**Addendum No. 1
September 20, 2024**

Project: LATC Surgical Technology Renovation
Lake Area Technical College
Watertown, South Dakota

Architect: CO-OP Architecture

M600

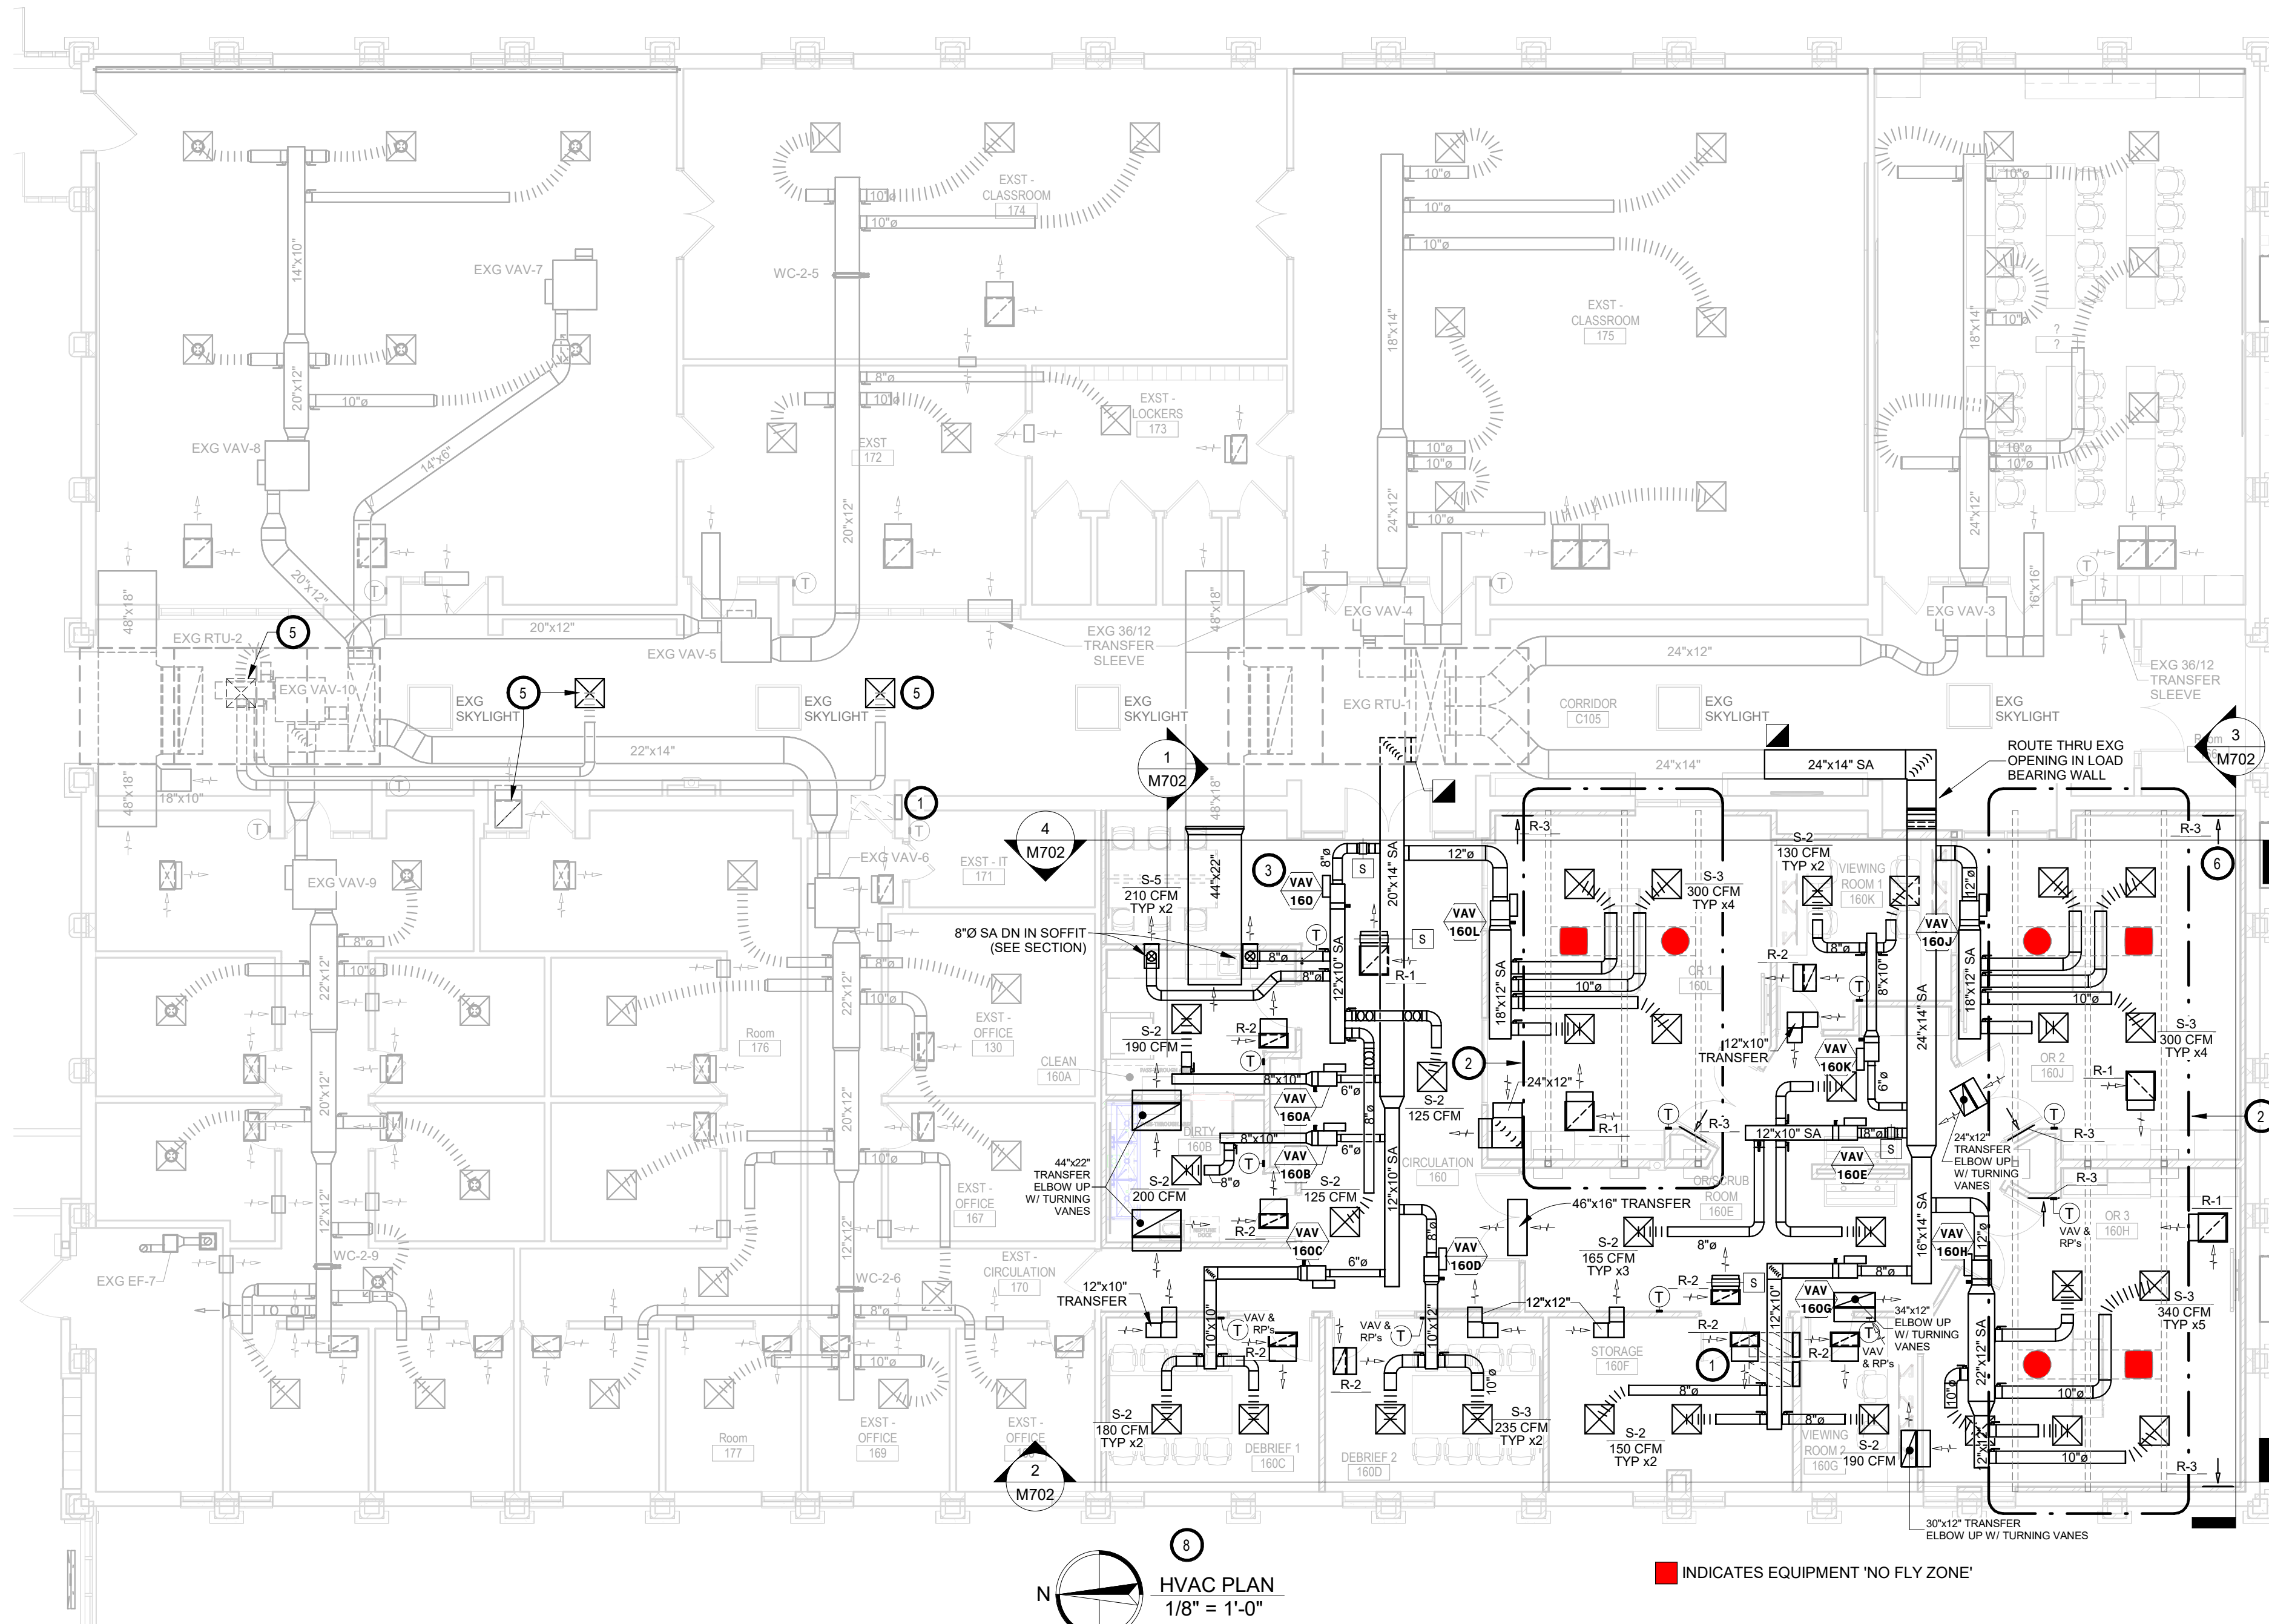
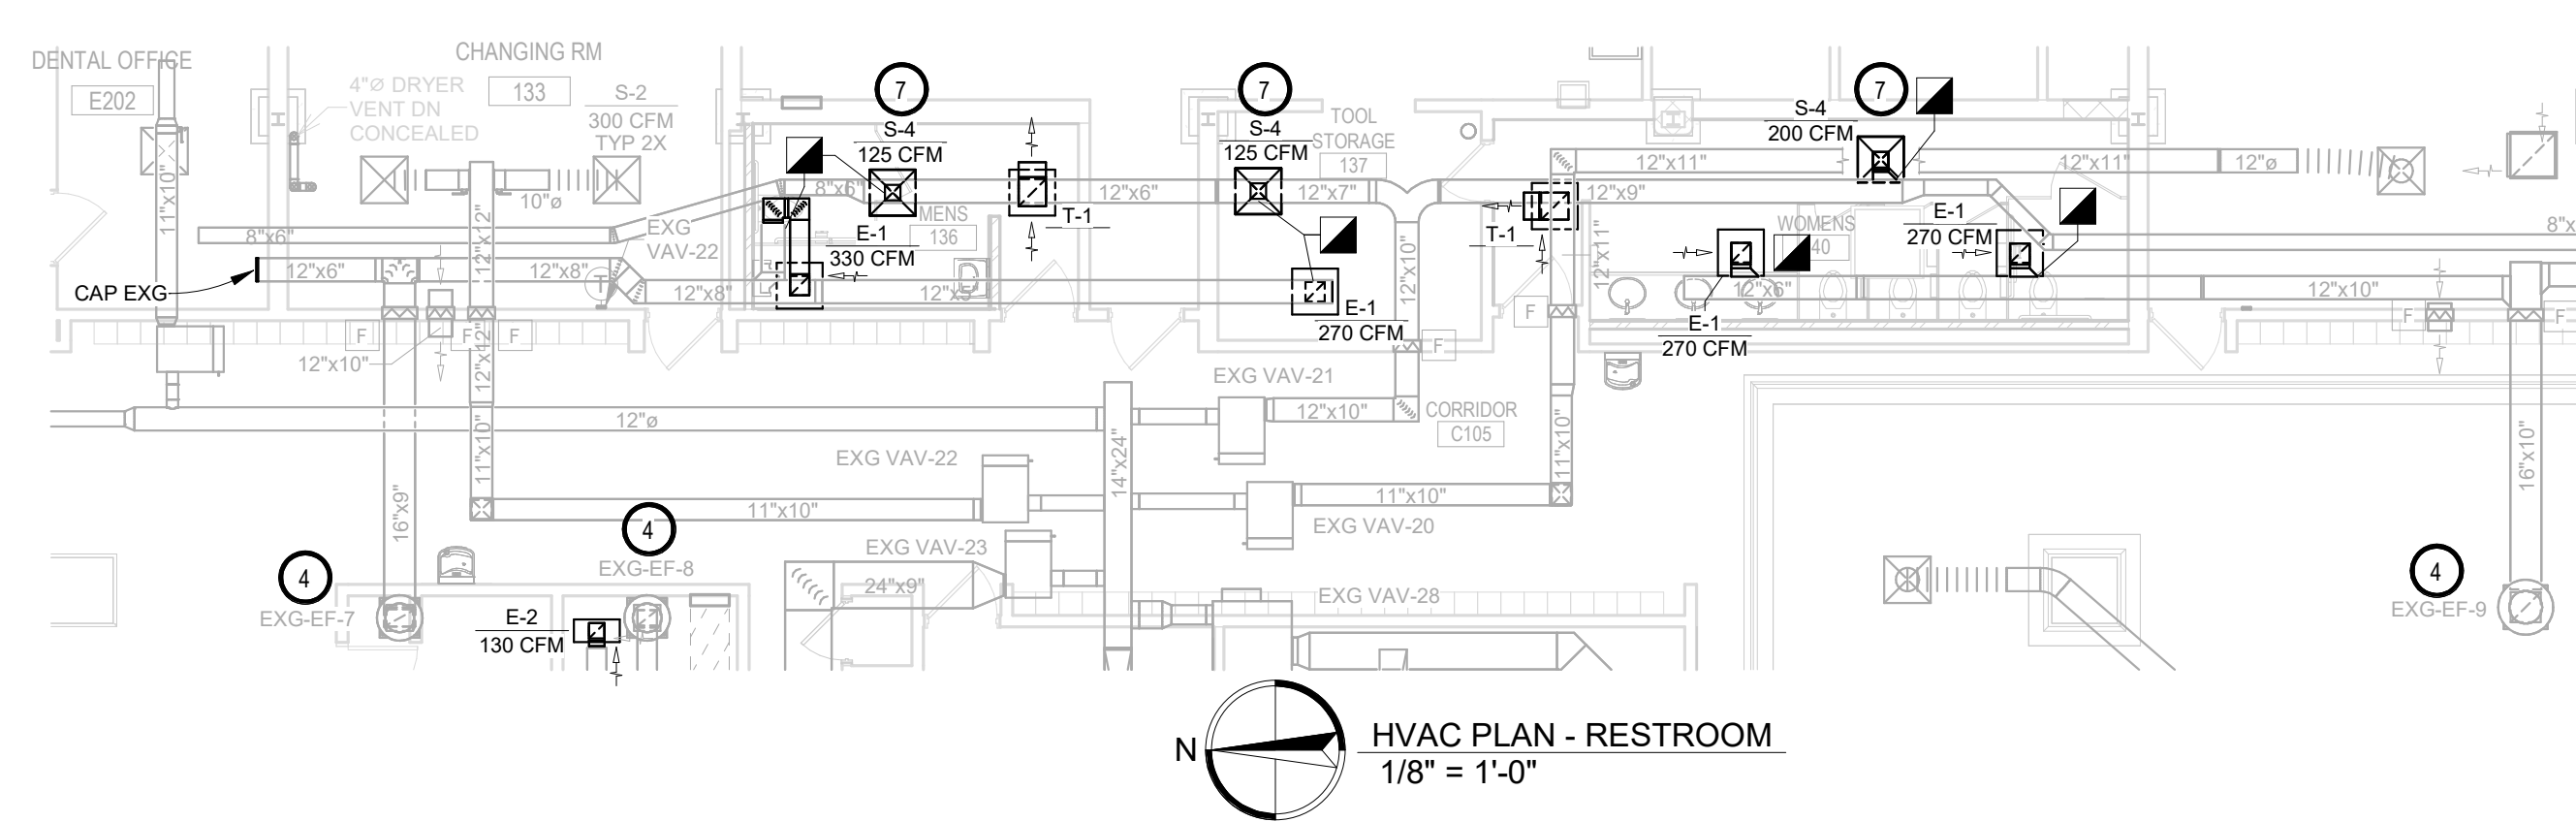
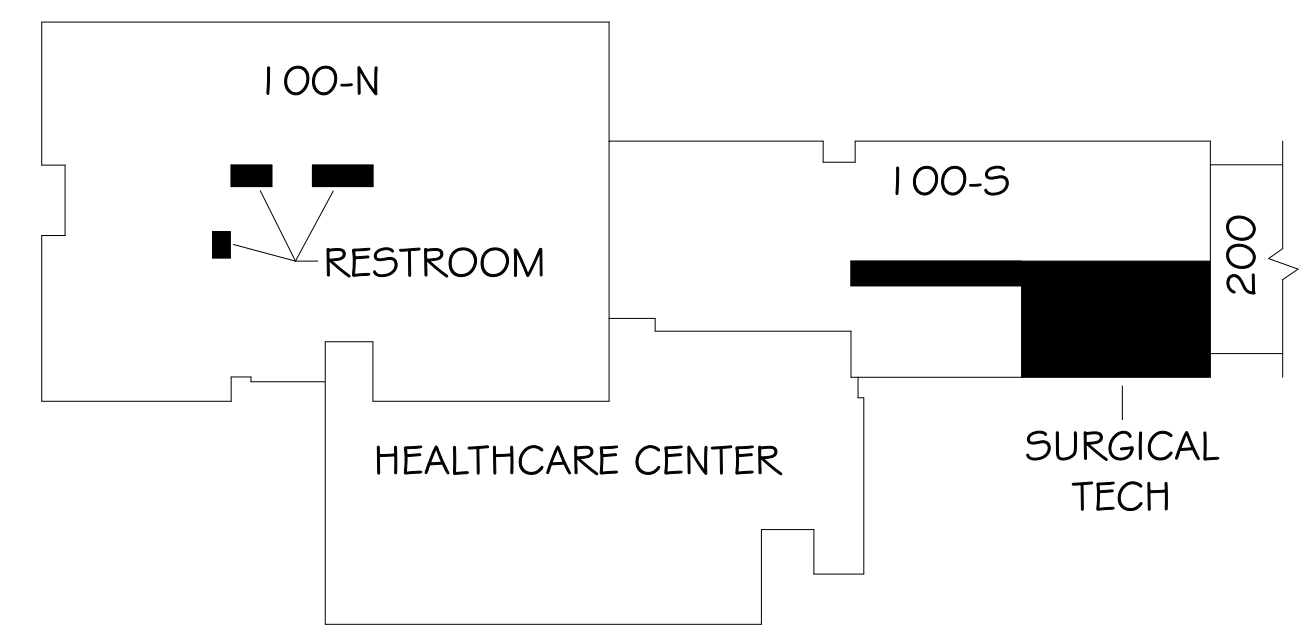
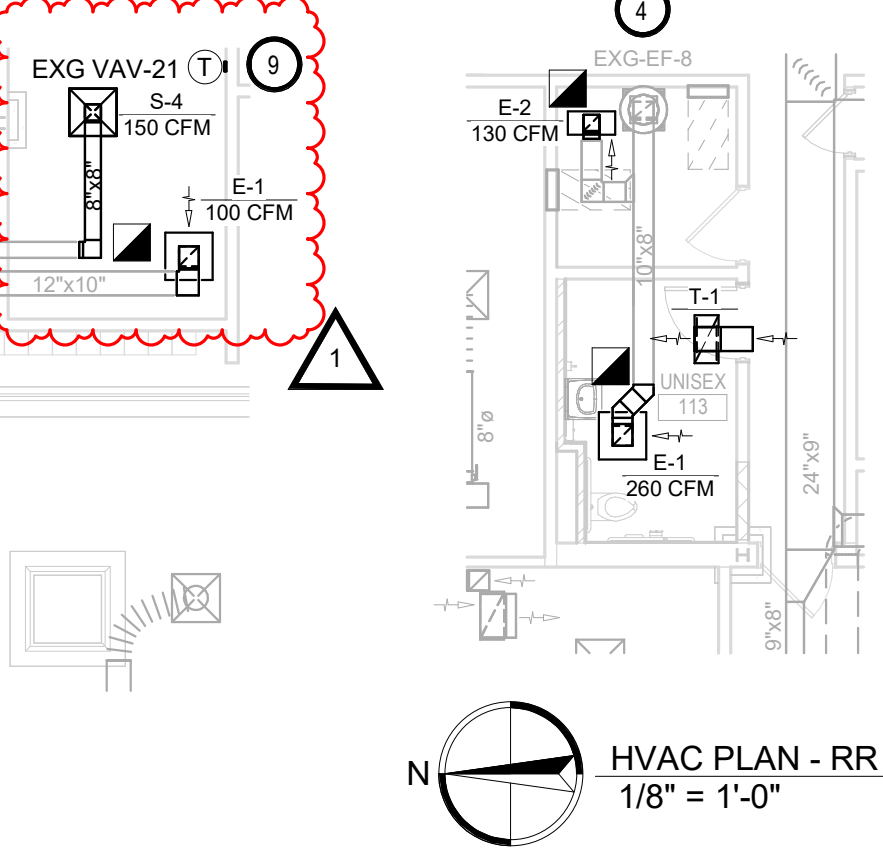
5. Sheet M600 – HVAC Plan – See the attached revised sheet for revisions to HVAC in existing shop office.
